Independent Review of the
Bowdens Silver Pty Limited
Surface Water Assessment – Updated
(WRM Water + Environment Pty Ltd
February 2022)

This analysis considers the data used in the Bowdens surface water assessment (WRM Water & Environment Pty Ltd) to do the modelling showing the viability of water use and reuse at the proposed mine site.

Figure 1 Average monthly rainfall data presented in Bowdens surface water assessment

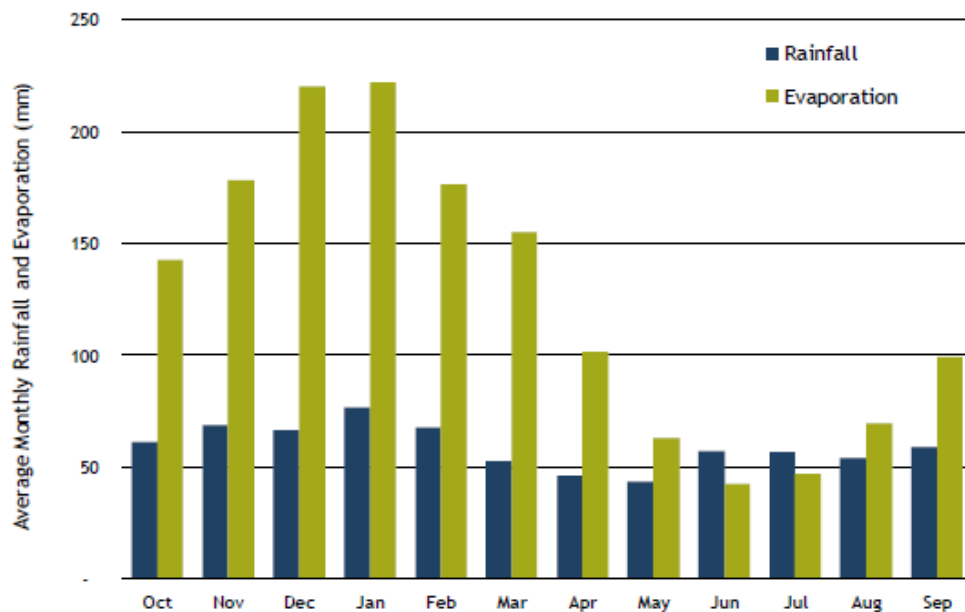
The Bowdens surface water assessment data appears to show a monthly average that exceeds 75mm over summer. This is incorrect, as evidenced by the rainfall data from Mudgee (26km west of the mine site), Rylstone (22km south of the mine site) and Lue.

Many of the other months are also too high when compared to Mudgee, Rylstone and Lue rainfall statistics from BOM. These figures need to be presented as numbers so they can be clearly understood.

Figure 5 Annual monthly rainfall data presented in Bowdens surface water assessment

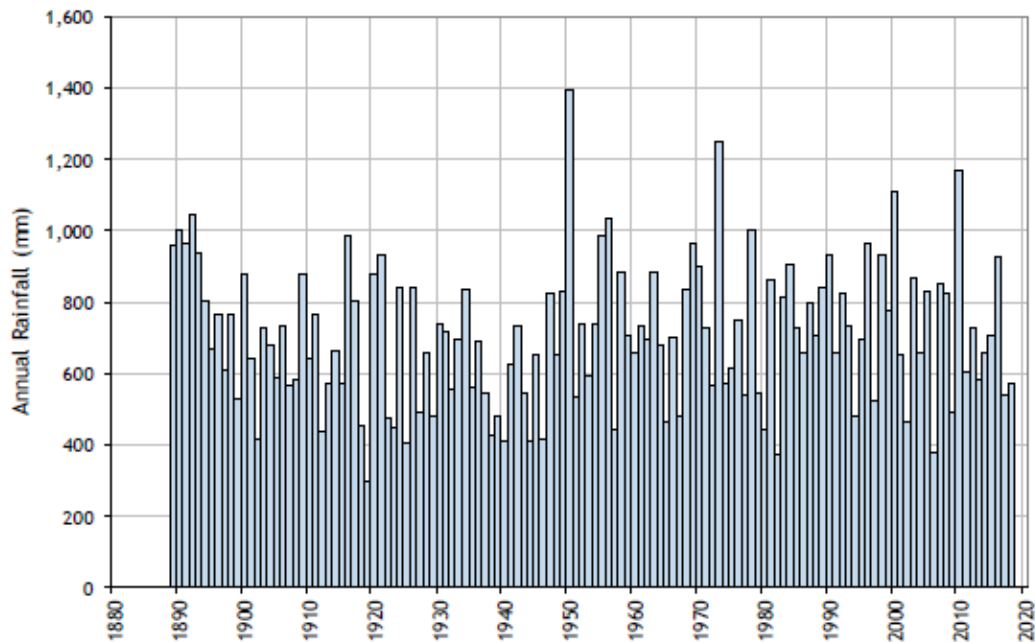
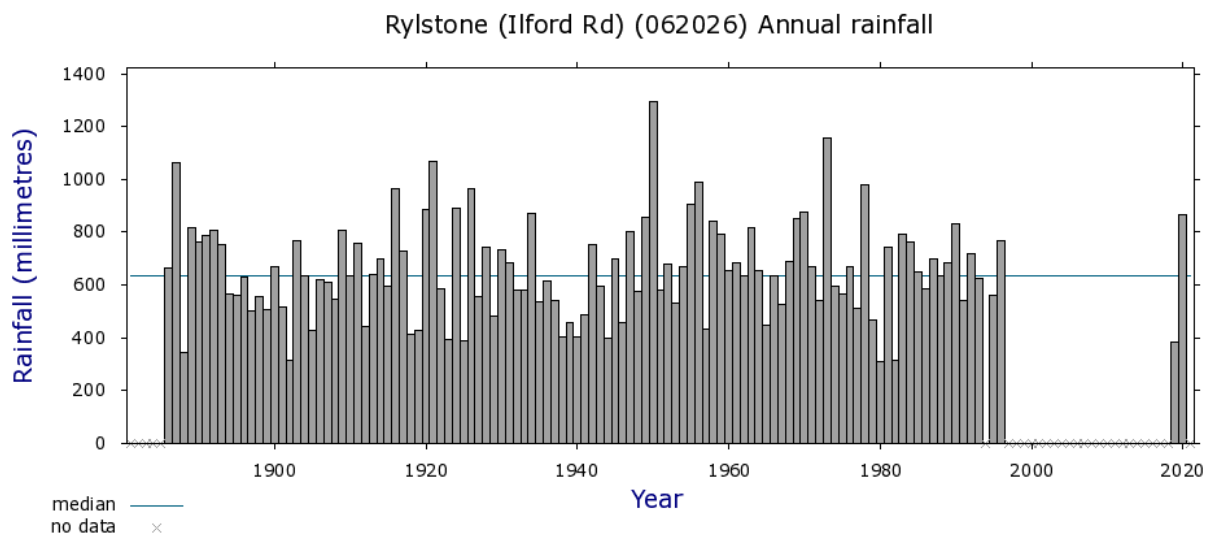
Average annual rainfall reported as 673 mm/a.

The number of very low rainfall years is clearly not reflected in the Bowdens surface water assessment annual rainfall data, which has only three years of less than 400mm. This in part seems to be a deliberate attempt to distort the data, as it has excluded 1888 and 2019, both of which are very dry years. Given that the community that will be affected by this mine have recently lived through the crippling drought which culminated in the 2019/2020 Black Summer fires, this is viewed very poorly.

WRM reported the average annual rainfall as 673 mm/a. The BOM reports the average annual rainfall for Mudgee as 671 mm/a and 654 mm/a for Rylstone. From Figure 8, it can be seen that the average annual rainfall for Lue is much less, at 614 mm/a. Given this, the estimate of 673 mm/a used by WRM for the surface water assessment is considered unrealistically high. Rather, it would be reasonable to use an estimate of 662 mm/a, being the average of the recorded rainfall for Mudgee and Rylstone. However, it should also be noted that the area in which the mine site lies is generally regarded as being within a rain shadow, with the Great Divide lying to the east and another mountain range to the west. Thus, an average annual rainfall of no more than 654 mm/a may be a more realistic estimate.

Figure 8 Rainfall cumulative distribution frequency

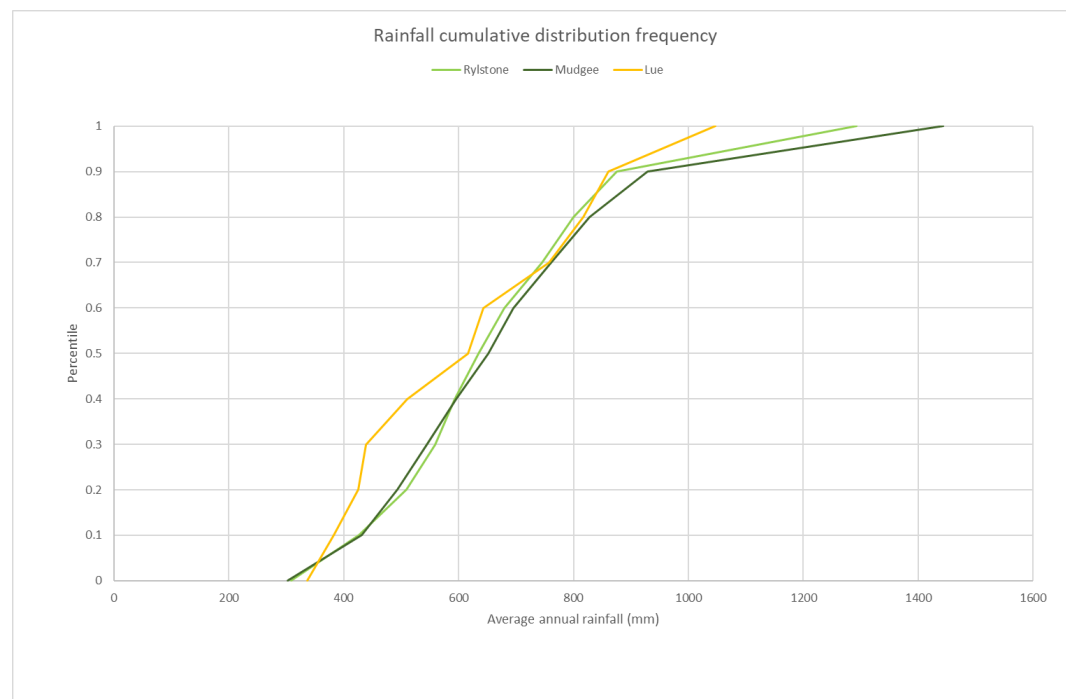
The percentiles for Mudgee, Rylstone and Lue have been calculated using BOM data and are shown in Table 5 and Figure 8. Based on the data from Mudgee and Rylstone, one in every five years, climatic conditions are akin to a semi-arid environment. The data from Lue shows that semi-arid conditions could be experienced two in every five years.

It is also noteworthy that the median for Rylstone and Mudgee is 635 and 656 mm/a respectively, and the 20th percentile is 509mm/a and 494 mm/a respectively. The 20th percentile for Lue is 425.7mm and the 40th percentile is 510.5mm. The point of this is that in Australia, a semi-arid climate is one where average rainfall is between 250mm and 500mm per year⁹. The analysis here shows that one in every five years, the climatic conditions for Rylstone and Mudgee are semi-arid. The data from Lue, adjacent to the proposed mine site, shows that semi-arid conditions could be experienced two in every five years. This means that any loss of available water in these years severely impacts the land, and the people, plants and animals trying to survive on it.

Figure 10 Regional Biophysical Strategic Agricultural Land (BSAL)

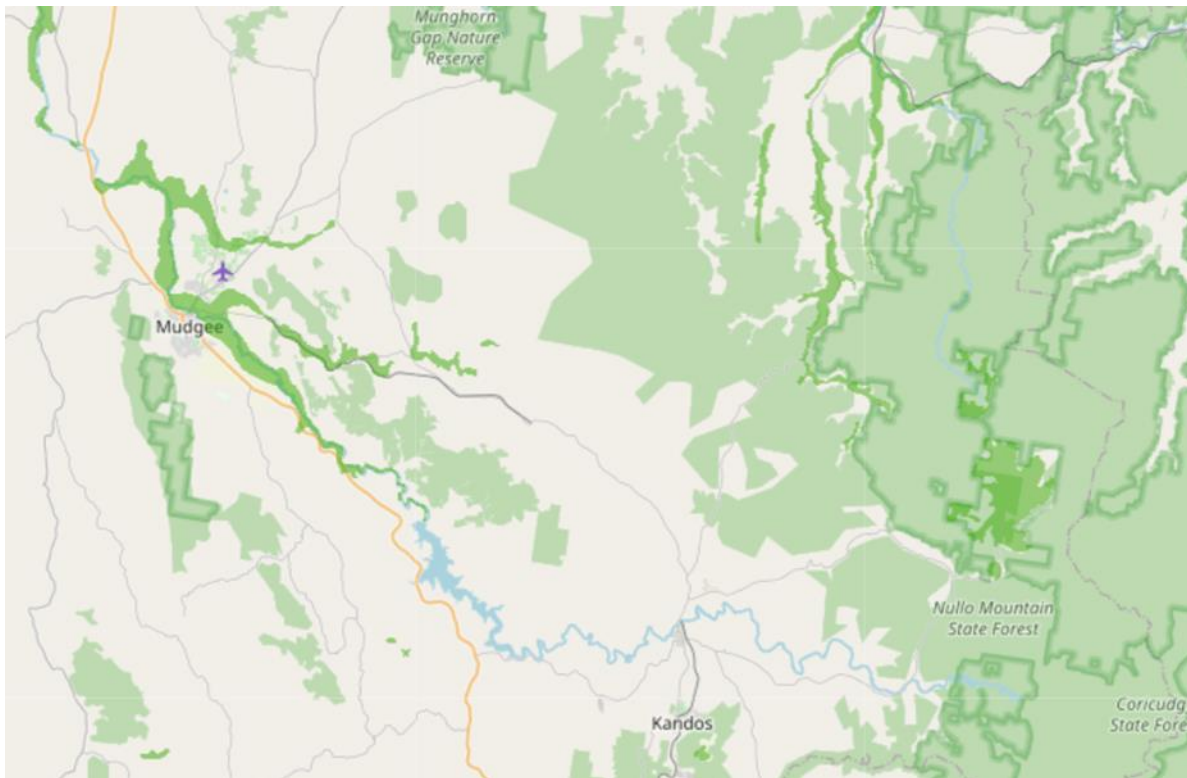
Downstream of the proposed mine site, there is BSAL present (Figure 10). The surface water assessment has not considered the impacts of using water from within Bowdens' holdings on this land.

As has been demonstrated in the analysis in this paper, the catchment in which the mine site is proposed has a high variability in rainfall and frequently experiences dry years. The water that supports the BSAL land moves through the upstream catchment and then is available to support agriculture in the mapped areas. Any mining within the supporting catchments threatens the water resource in the BSAL areas. The proposed mine will interrupt both groundwater and surface water flows, and as such, the BSAL area is at risk of losing the critical water which underpins its inherent value.
